STAFF REPORT: NOVEMBER 12, 2025 MEETING

APPLICATION NUMBER: HDC2025-00635

ADDRESS: 12512 BROADSTREET

SCOPE: REPLACE WOOD WINDOWS WITH FIBREX WINDOWS

Above: Façade dormer opening; Right: South/side wall opening. These windows are covered with wood storm windows (likely original) Applicant photos.

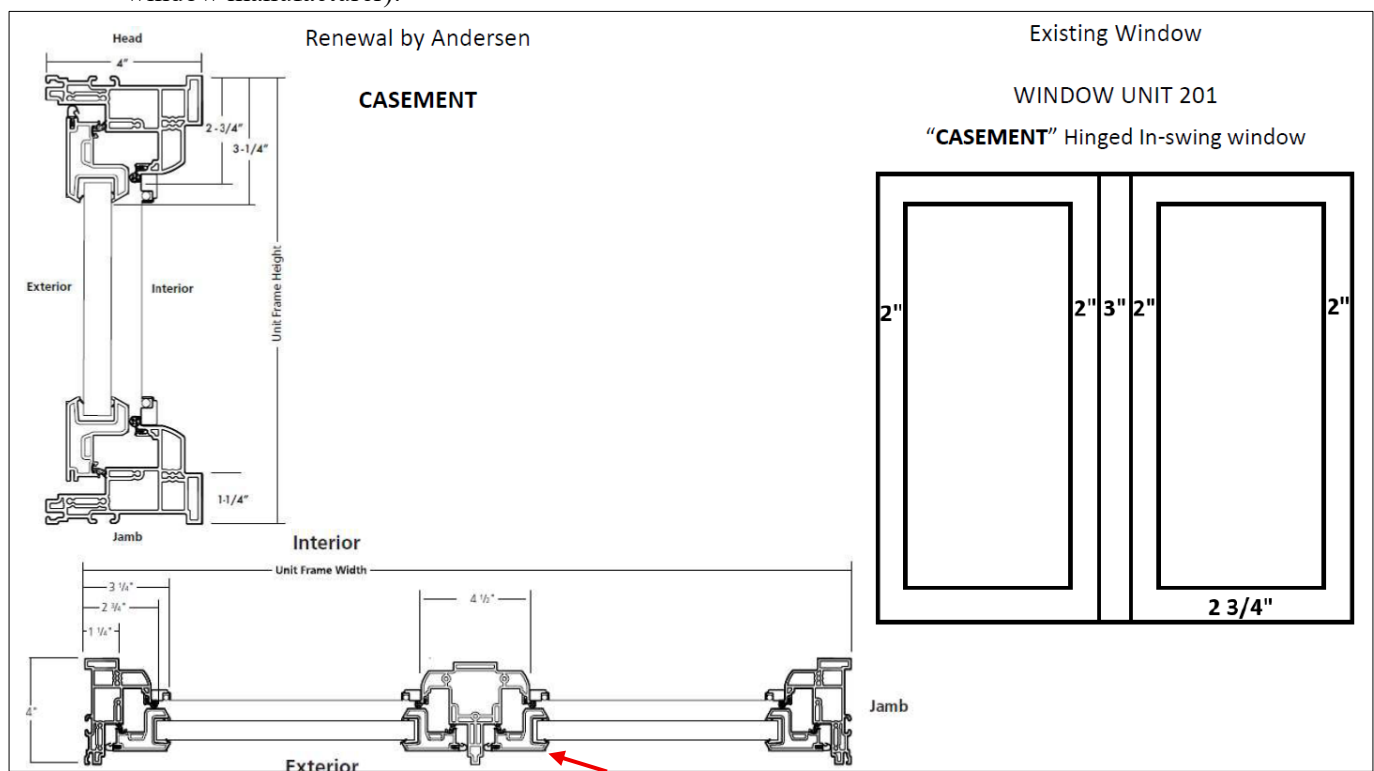
- Replacement windows at the first floor, right of the entrance are visible in the designation photo. Based on this image, staff assumes that the other existing replacement windows on the side walls pre-date the district.
- Leaded glass casement windows to the left of the front entrance are distinctive character-defining features, remain intact, and not part of this application.
- The windows on the façade at the second floor are casement units, with wood frames and undivided glass. The storm windows with a central meeting rail obscure the casement operation.
- The double-hung wood windows on the side walls, four with a six-over-one pattern and two with a four-over-one pattern are proposed for replacement.
- Two openings: front, second floor shed dormer and south side wall, first floor near the rear, have wood mullions that are part of the larger window opening.

- Based on the written description and photos provided, it is staff's opinion that the existing windows need repair (including the wood sills), but the frames remain intact and are not demonstrated to be deteriorated beyond repair.
- The Russell Woods-Sullivan historic district's Element of Design (Sec. 21-2-168) that relate to this proposal are:

These casement window sections illustrate staff’s concerns over the manufactured mullion that would be fabricated as part of the double casement window opening. Applicant document.

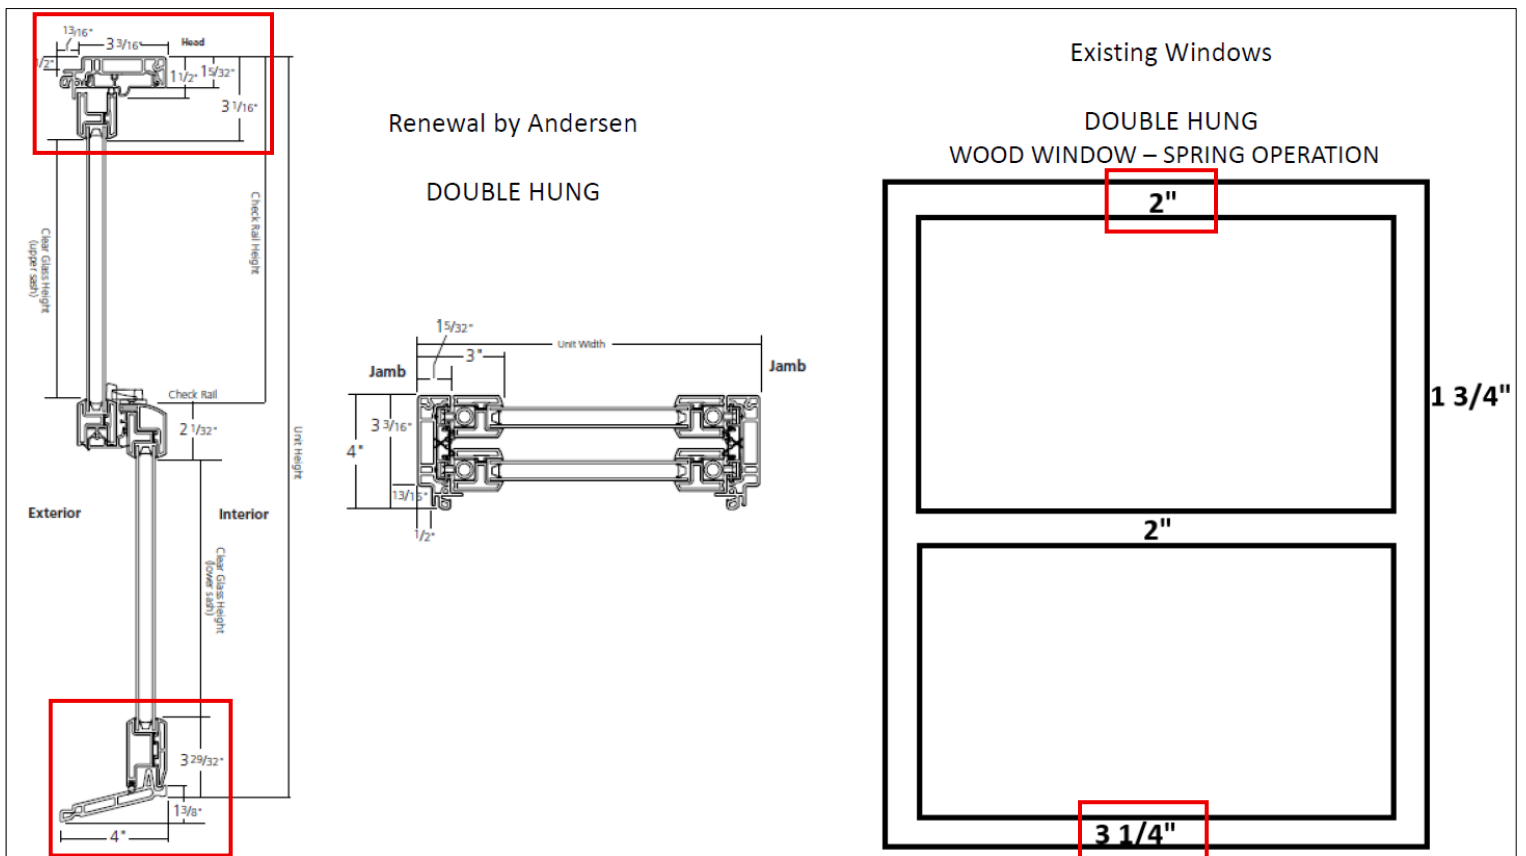
- As discussed on the previous page, the wood mullions on the front and south walls are part of the wood trim of the larger window opening and is a distinctive character-defining feature which should remain intact. Therefore, the double casement window should be changed to two (2), single casement units (regardless of window manufacturer).

Google street view, June 2019 (l) and June 2018 (r)

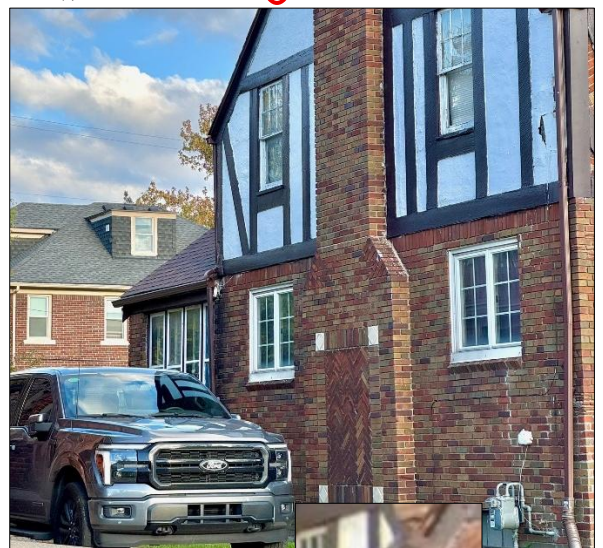
- During staff's research of the property for this application, the following alterations were identified:
 - Replacement of asphalt shingle roof with new asphalt shingle roof
 - Removal of downspouts (which appear to be round) and collector boxes.
- Staff will notify the applicant of the unapproved work and to see if they would like add the roof and gutter/downspout scope of work to this application.
